10 Mb/s Single Twisted Pair Ethernet 10BASE-T1L Receive State Diagram Disparity Error

Steffen Graber
Pepperl+Fuchs

10BASE-T1L Receive State Diagram

Changes (in red) to:
Figure 146-8 – PCS receive state diagram (part a)

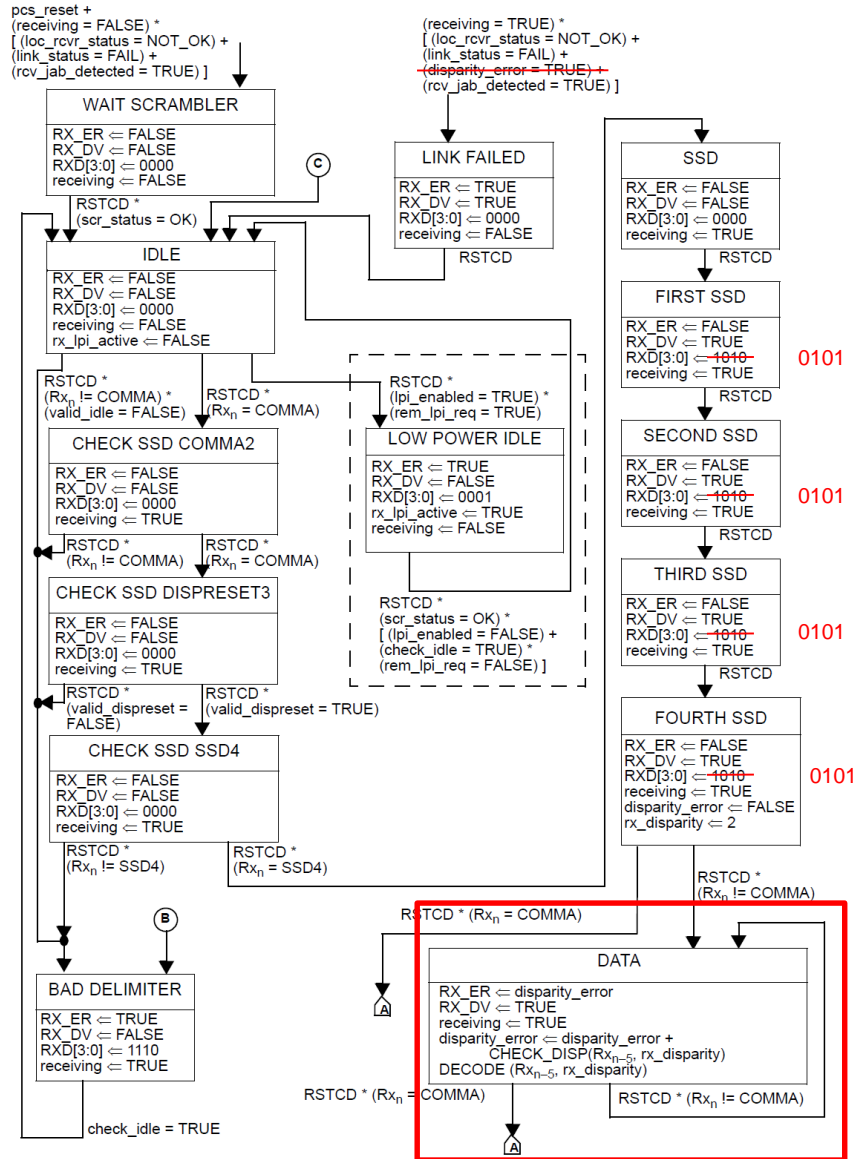
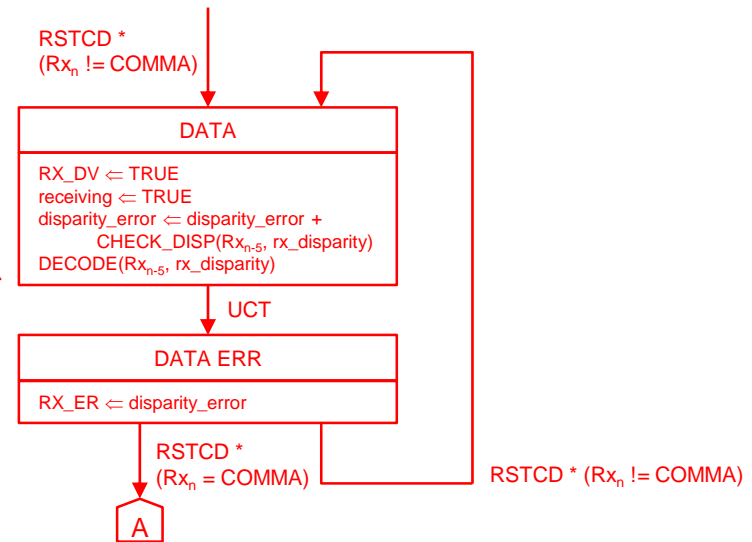
- The PCS receive state diagram in Draft D2.1 has several states (DATA, CHECK ESD COMMA2, CHECK ESD DISPRESET3, and CHECK ESD ESD4), where the variable disparity_error is modified, but also used in the same state.

- As the equations provided in a state are only executed once the state is entered and as the order of the equations within the state is not relevant for the order of the command execution, it is not clear, if RX_ER is using the old value of the disparity_error variable or already the updated value.
- To prevent this unclear situation additional states for setting RX_ER are introduced.
- In state ESD there is no update of the disparity_error variable necessary, therefore a simple “or” condition can be used:

- Additionally some minor corrections in two transitions of the state diagram and in the patterns recovering the preamble are done.
- All changes can be seen on the next two pages.

$$\text{RX_ER} \leftarrow \text{disparity_error} + \text{CHECK_DISP}(\text{Rx}_{n-5}, \text{rx_disparity})$$
